**APPEAL UNDER SECTION 47(2) OF THE TOWN AND COUNTRY PLANNING (SCOTLAND) ACT
1997 BY DART ENERGY (FORTH VALLEY) LTD CONCERNING COAL BED METHANE
PRODUCTION, INCLUDING DRILLING, WELL SITE ESTABLISHMENT AT 14 LOCATIONS AND
ASSOCIATED INFRASTRUCTURE AT LETHAM MOSS, FALKIRK, AND POWDRAKE ROAD,
NEAR AIRTH, PLEAN**

(REFERENCES PPA-240-2032 AND PPA-390-2029)

PRECOGNITION BY PROFESSOR DAVID K. SMYTHE

CONCERNED COMMUNITIES OF FALKIRK

Fig. 16. The PDA in relation to faulting (red lines) and the OS map.

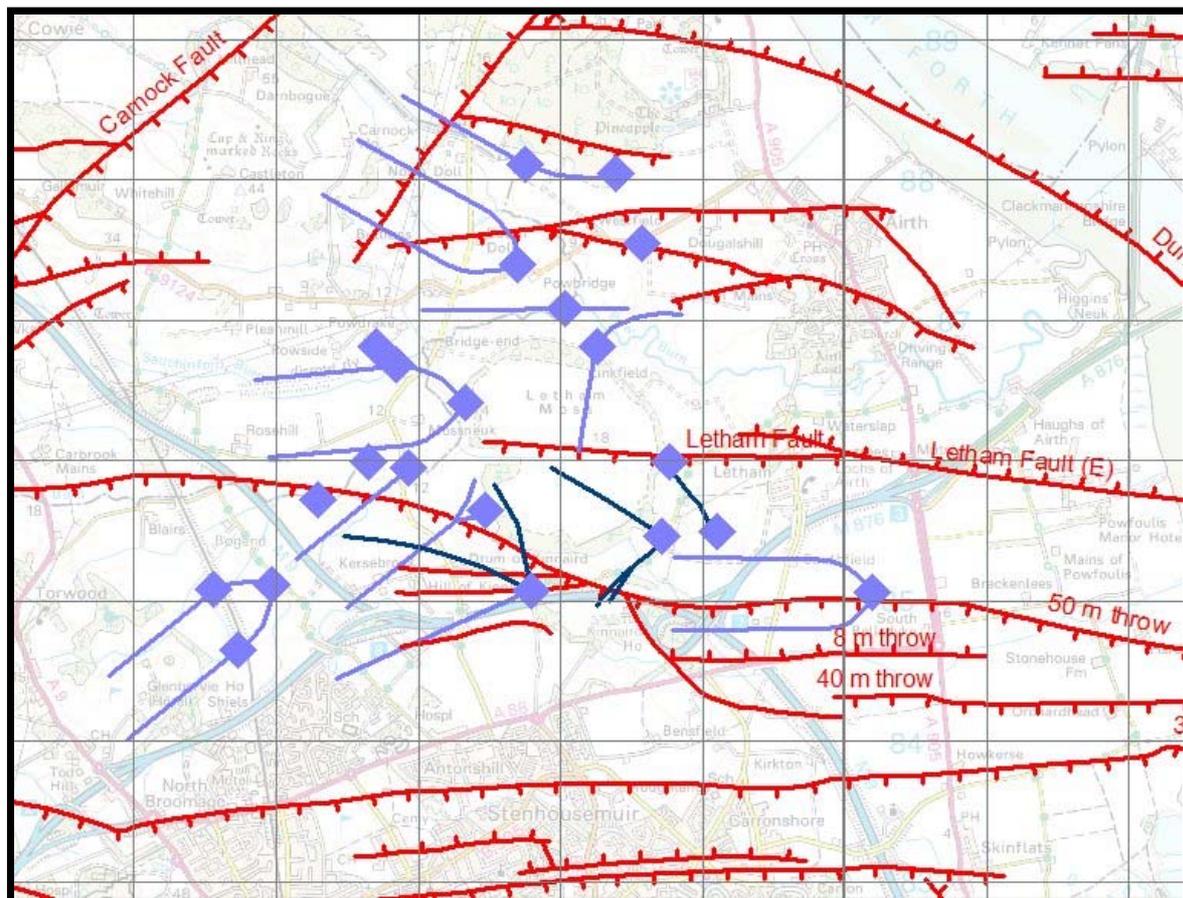
3.1.2 Several of the proposed horizontal wells cut the faults. Allowance must be made for the slight difference in the underground location of the faults, since they are likely to have a hade (a dip, or slope, usually on the downthrown side; see for example the faults shown in the seismic sections in Figures 9 and 11 above); however, the location of the faults at 800 m or so below the ground surface will probably lie between 100 m and 250 m of the surface location, on the downthrown side.
